STAFF REPORT

HEARING 2/22/2022

SUBJECT: H-2021-0071
Lennon Pointe Community

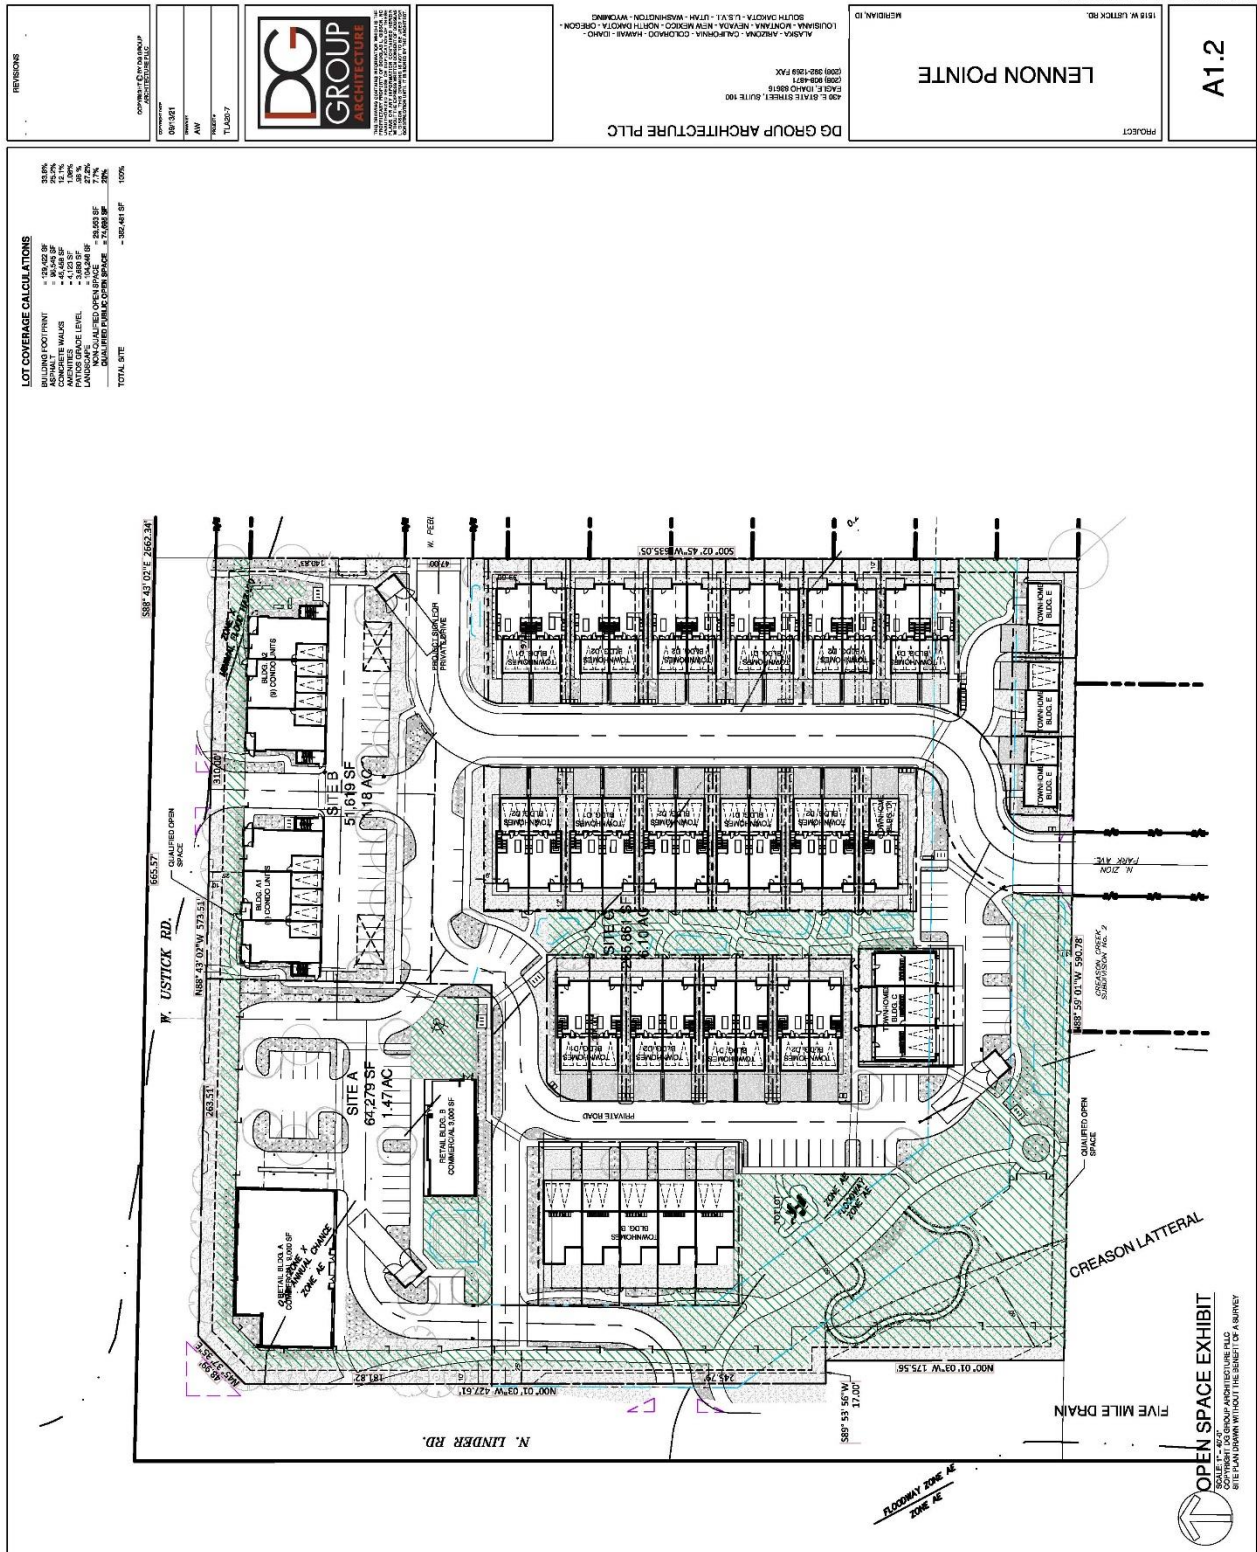
*In addition, an area of the Creason Lateral and Kellogg Drain irrigation easements underlay a large portion of the landscape buffer along Linder Road that is currently shown with trees. Staff anticipates the applicable irrigation district will not allow trees within their easements so the landscape plans should be revised to show the removal of trees from the easement area. Furthermore, code requires that if a required landscape buffer is encumbered by easements, at least 5 feet of landscaping be proposed outside of the easement area to include the required number of trees. **Because of the extensive impediment these two irrigation facilities create in this area of the site, Staff does not find it feasible to comply with this code requirement in its fullest extent as it would require half of the site to shift to the east reducing the width of the new in the center of the development. Staff finds the trees that are allowed outside of the easement area, the placement of the access point to Linder, and the separation of the townhome units from Linder offer appropriate and adequate landscaping and buffering. However, to formalize this finding and comply with code, the Applicant should apply for Alternative Compliance with the first final plat application.***

According to the submitted landscape plans, the proposed regional pathway in the southwest corner of the site is also within the Kellogg Drain irrigation easement which generally does not allow trees and minimal landscaping. The submitted landscape plans show no trees proposed within this easement.

- 3. The landscape plan included in Section VII.D, dated September 15, 2021, shall be revised as follows prior to submittal of the Final Plat application:

- a. Revise the location of the trees for the Linder Road street buffer to be outside of any waterway easement.
 - b. Shift the proposed regional pathway on Lot 1, Block 1 to the west to better align with the approved segment to the south in Creason Creek No. 2.

- c. Show the required 25-foot landscape buffer between the C-C zoning district and the R-15 zoning district as required by UDC 11-3B-9C.
 - d. Revise the landscape plan to match the revised preliminary plat and site plan dated January 2022.

E. Site Plan (Revised January 2022)

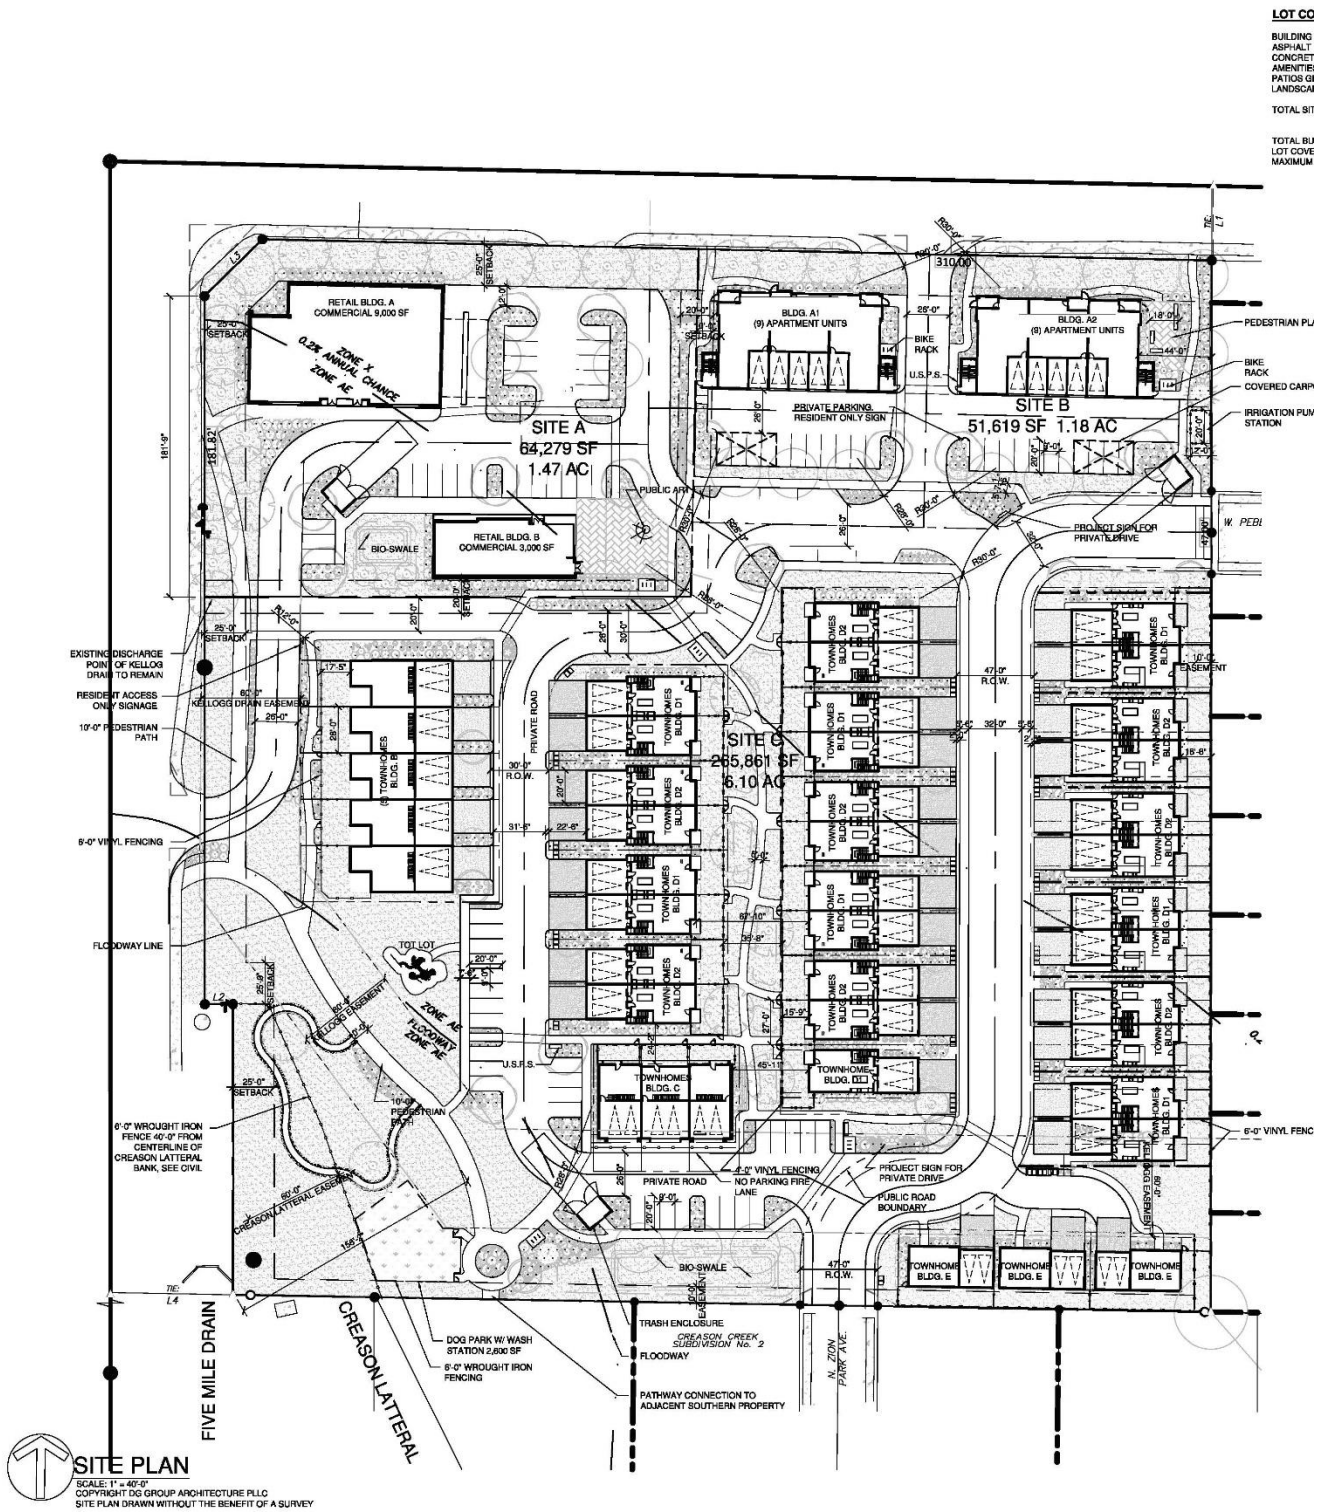
Furthermore, it appears the site plan shows building footprints too large for the proposed building lots—the building footprints do not meet the minimum building setback to the entrance sidewalks of 10 feet. When future building permits are submitted, the Applicant will be required to show compliance with all R-15 dimensional standards as outlined in [UDC Table 11-2A-7](#).

A portion of one of the building lots (Lot 2, Block 1) is shown on the preliminary plat and site plan within the floodplain area. The building footprint is not so this technically complies with City and floodplain standards. However, to ensure the future homeowner has the easiest access to use their property, Staff recommends this 6-unit townhome building be shifted to the north to get as much of the building lot out of the floodplain as possible. There is adequate room on the north side of this building for this to occur without any other changes to the development.

- 4. The site plan, as shown in Exhibit VII.E, shall be revised as follows prior to Final Plat submittal:
 - a. ~~Shift the 6 unit townhome building to the north to move as much of Lot 2, Block 1 out of the floodway zone.~~

- c. Show the required number of covered spaces for the proposed multi-family residential development, per UDC Table 11-3C-6.
 - d. Shift the proposed regional pathway on Lot 1, Block 1 to the west to better align with the approved segment to the south in Creason Creek No. 2.

F. Public Works – Water Markup

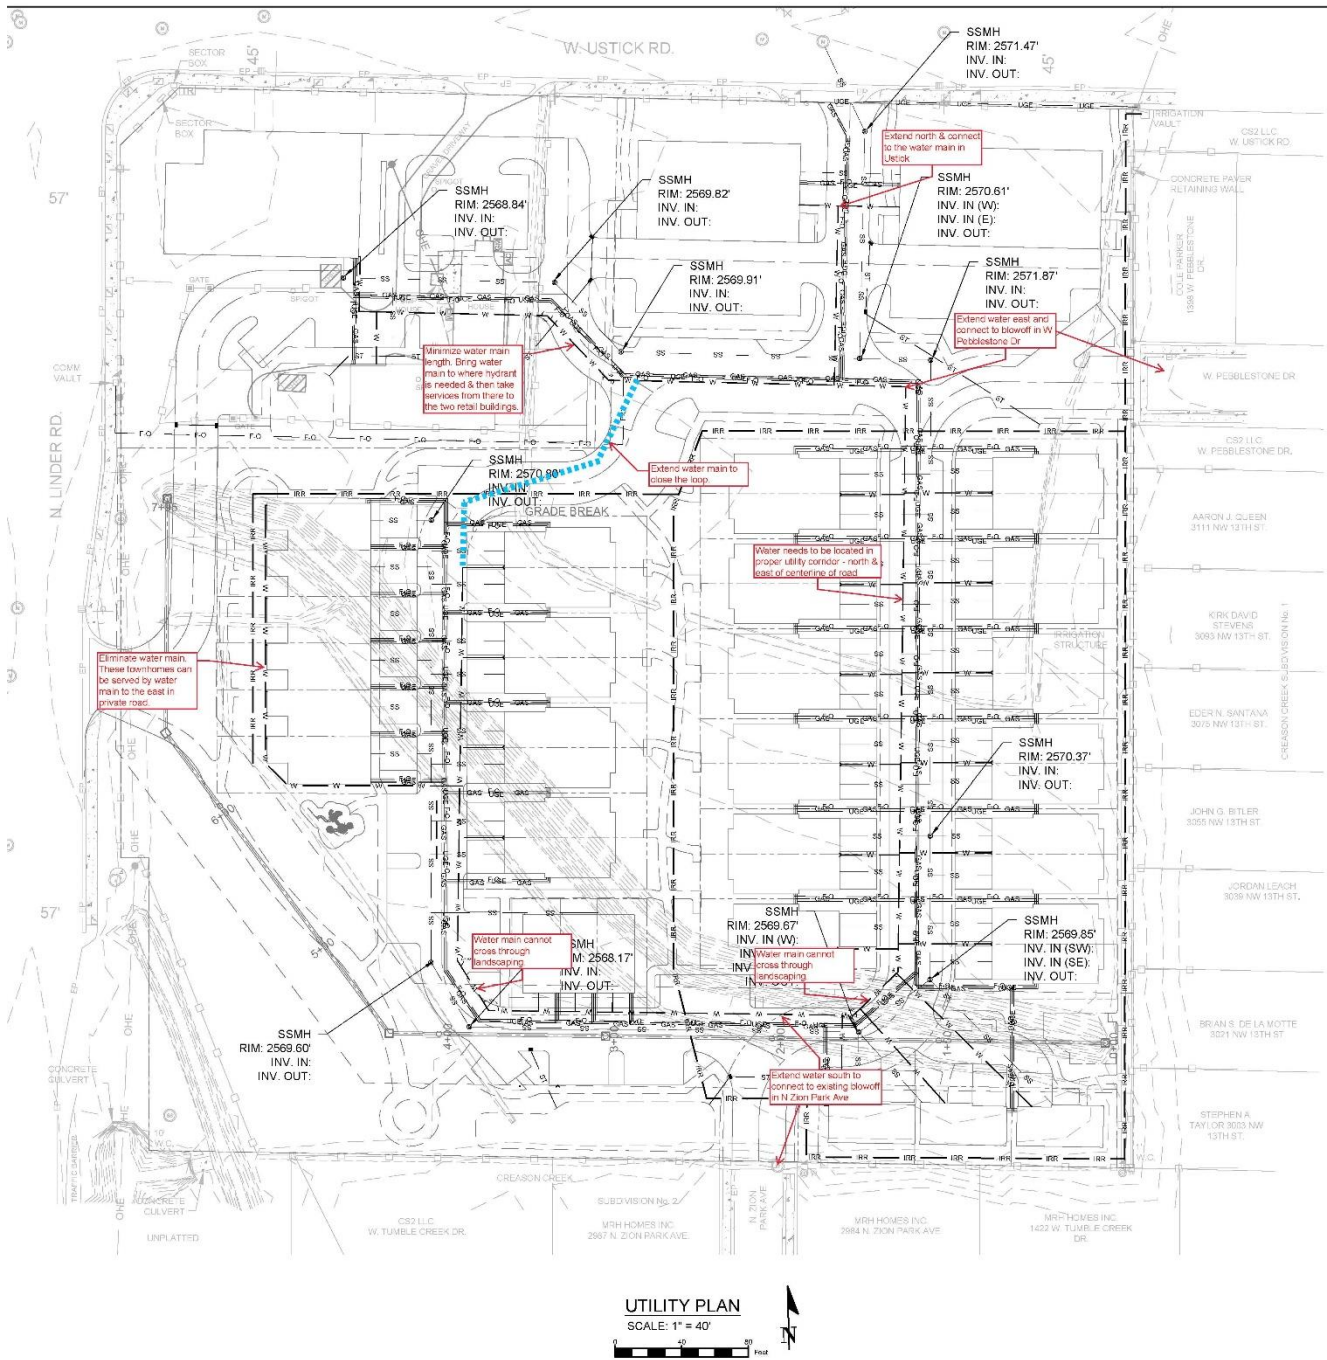
8. Minimize water main length near the commercial lot at the northwest corner of the development. Bring the water main only as far as needed to provide a hydrant for the buildings' fire protection. Extend service lines from the main to serve the two retail buildings.
